ADDENDUM NO. 1

RFQ CCC-078

**Administration Building Renovation
Compton Community College District**

tBP Project. No. 20987.00

9. Revised SHEET A7-1 ENLARGED TOILET PLAN

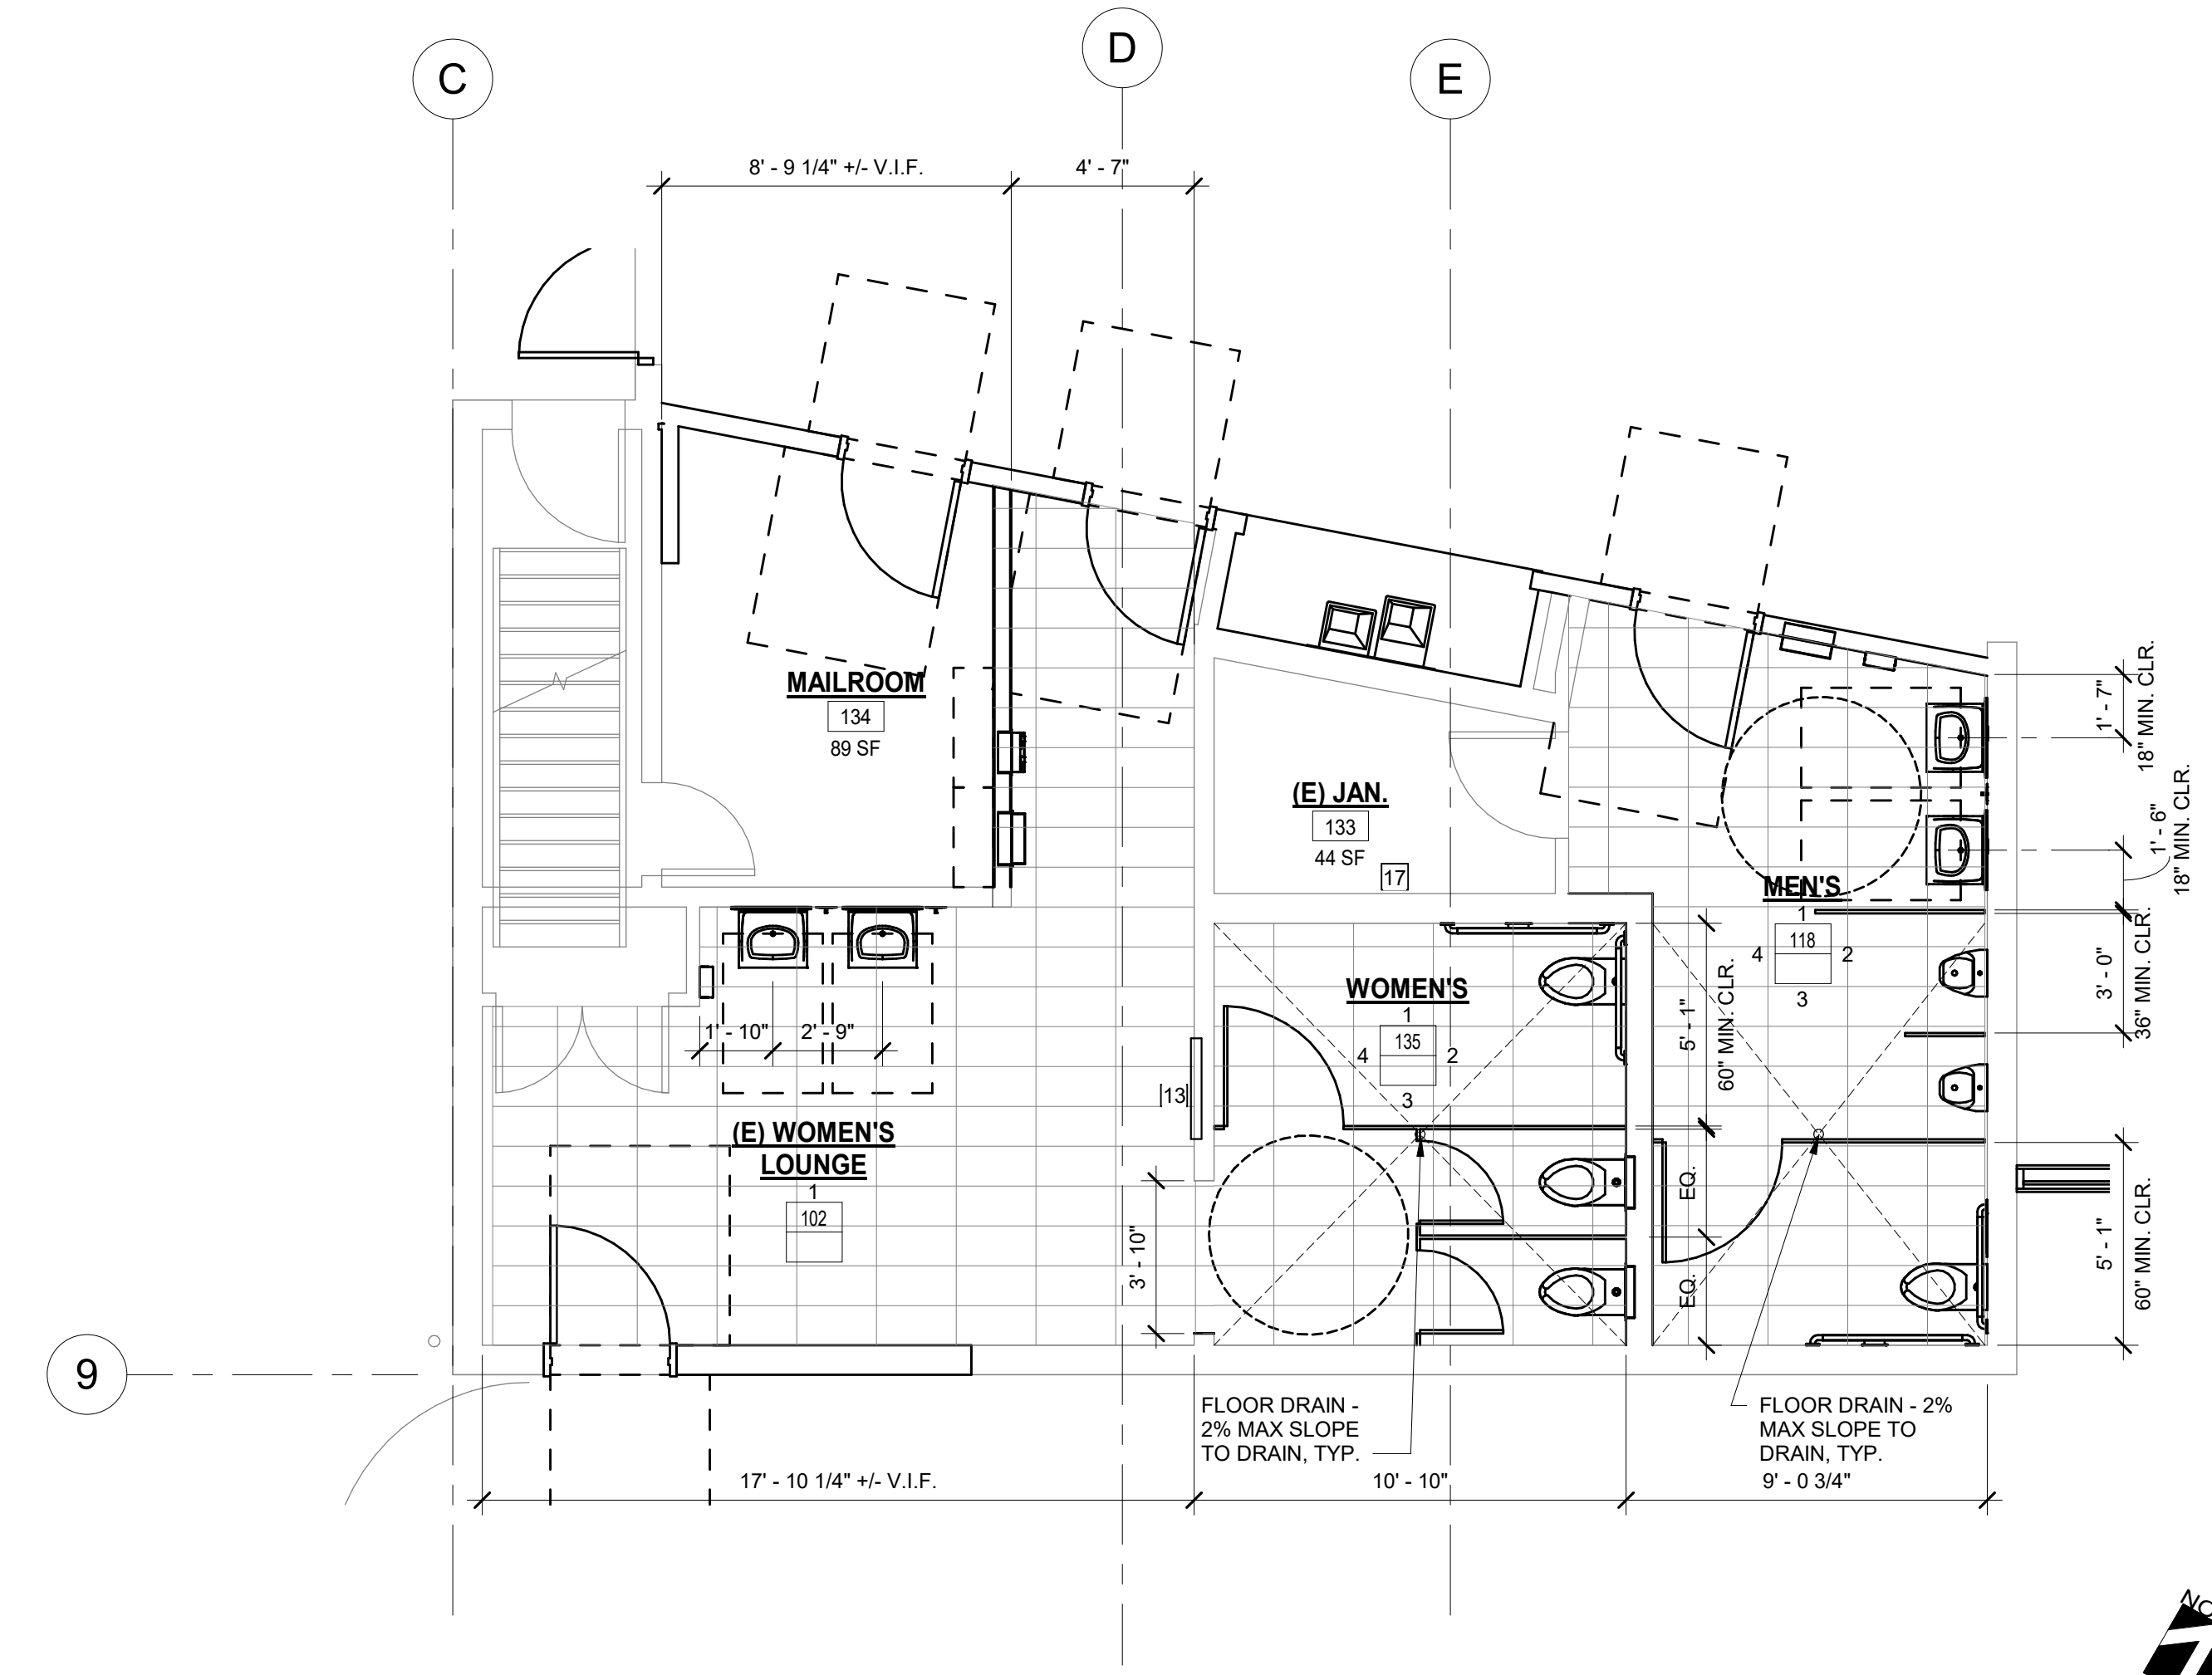
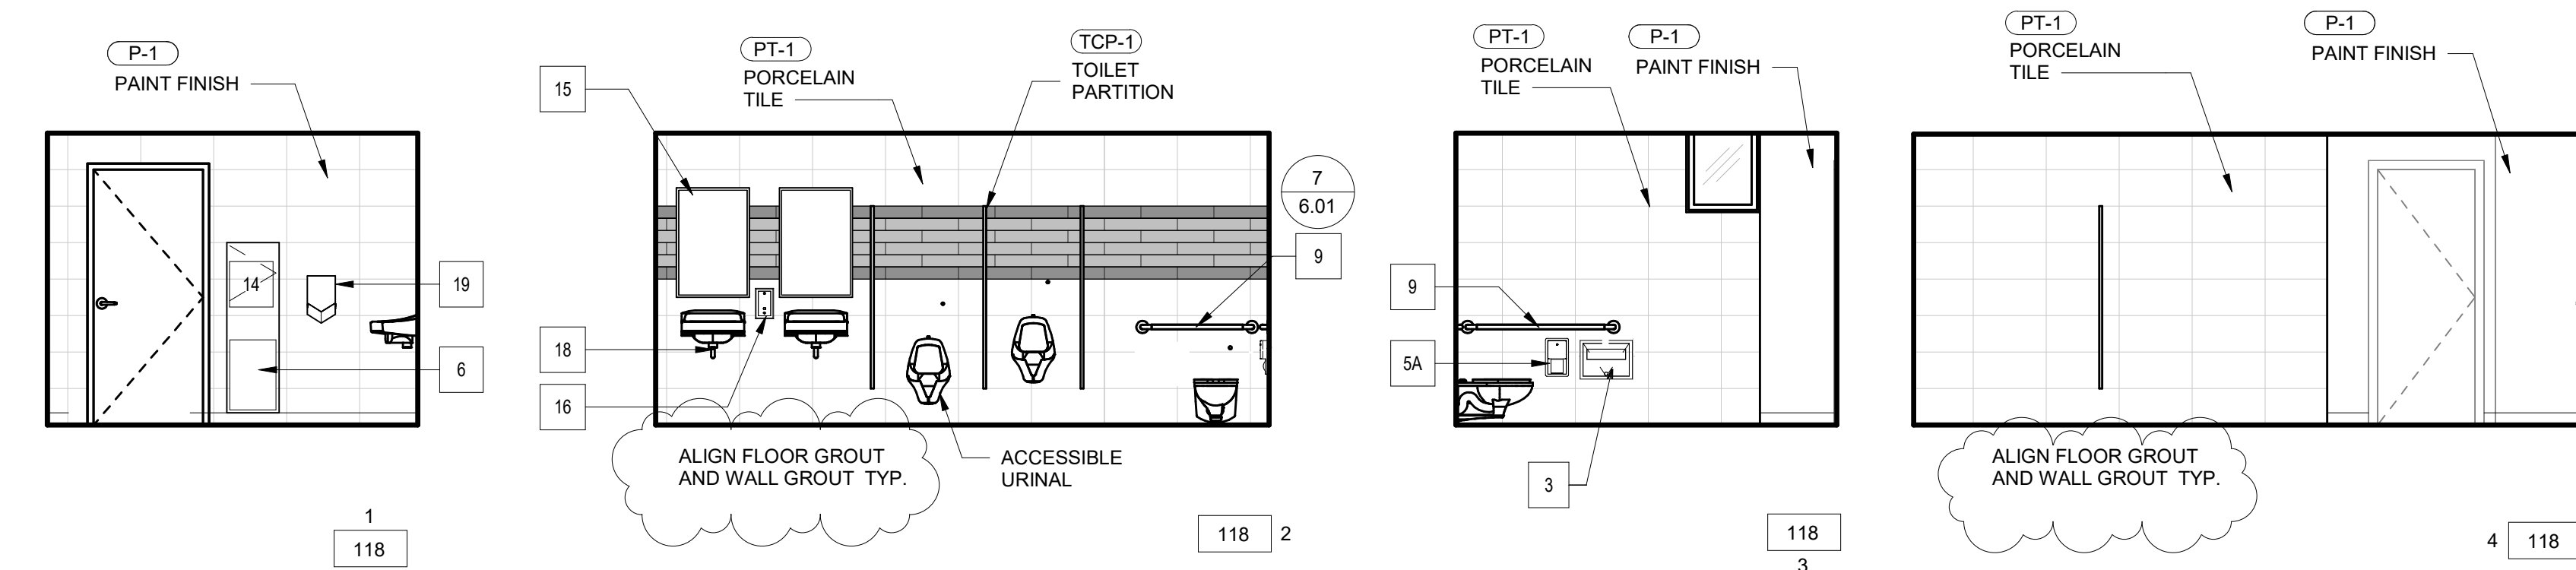
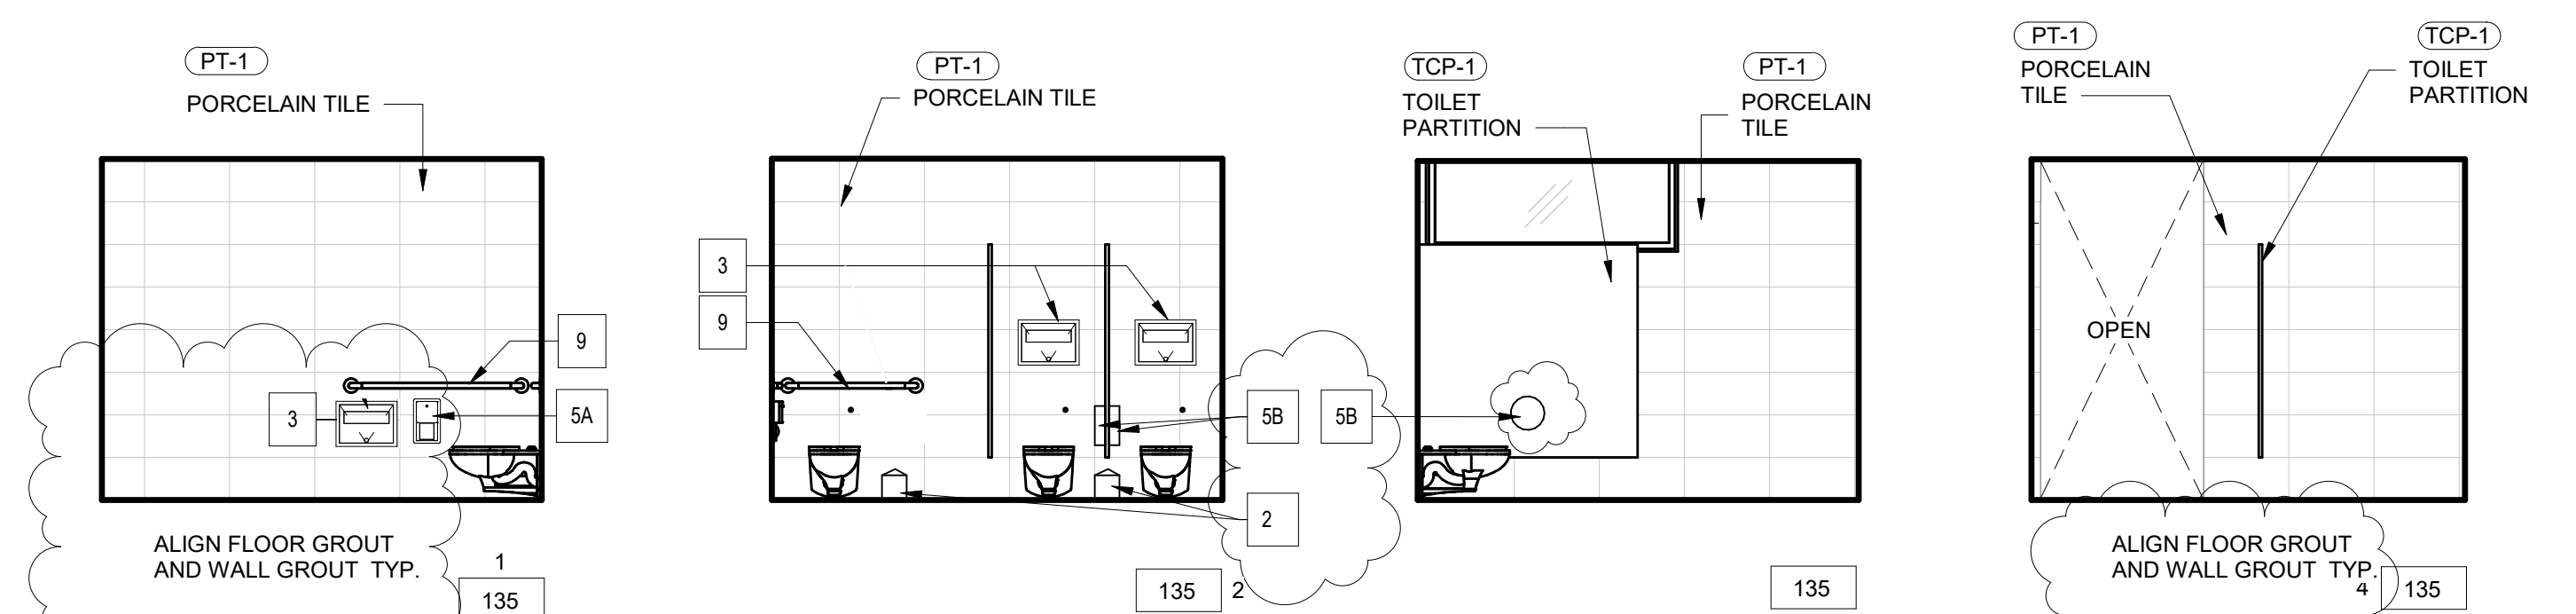
- a. Toilet Accessories Keynotes revised to ADD OFCI at non-ADA stalls.
- b. Added note for align wall grout with floor grout.
- c. Corrected some graphics at Women's Lounge.
- d. Shows DF relocation.
See attached revised Full size sheet identifying revisions included as part of this addendum.
